Peter E. Katz
Vice President
Calvert Cliffs Nuclear Power Plant
Constellation Generation Group, LLC

SUBJECT: Calvert Cliffs Nuclear Power Plant
Unit Nos. 1 & 2; Docket Nos. 50-317 & 50-318
License Amendment Request: Improvement to the Definition of Operations
Involving Positive Reactivity Changes

TECHNICAL SPECIFICATION MARKUP

3.4.7 RCS Loops - MODE 5, Loops Filled

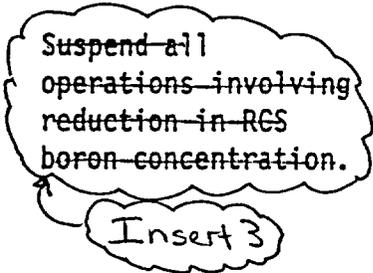
1. The SDC pump of the loop in operation may be not in operation for ≤ 1 hour per 8 hour period provided:
 - a. ~~No operations are permitted that would cause reduction of the RCS boron concentration; and~~

Insert 5

No operations are permitted that would cause introduction into the RCS, coolant with boron concentration less than required to meet the SDM of LCO 3.1.1; and

SDC and Coolant Circulation-High Water Level
3.9.4

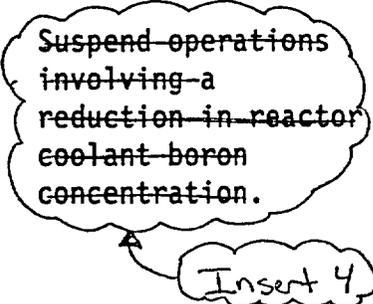
Suspend operations involving a reduction in reactor coolant boron concentration.

Insert 4

Suspend operations that would cause introduction into the RCS, coolant with boron concentration less than required to meet the boron concentration of LCO 3.9.1
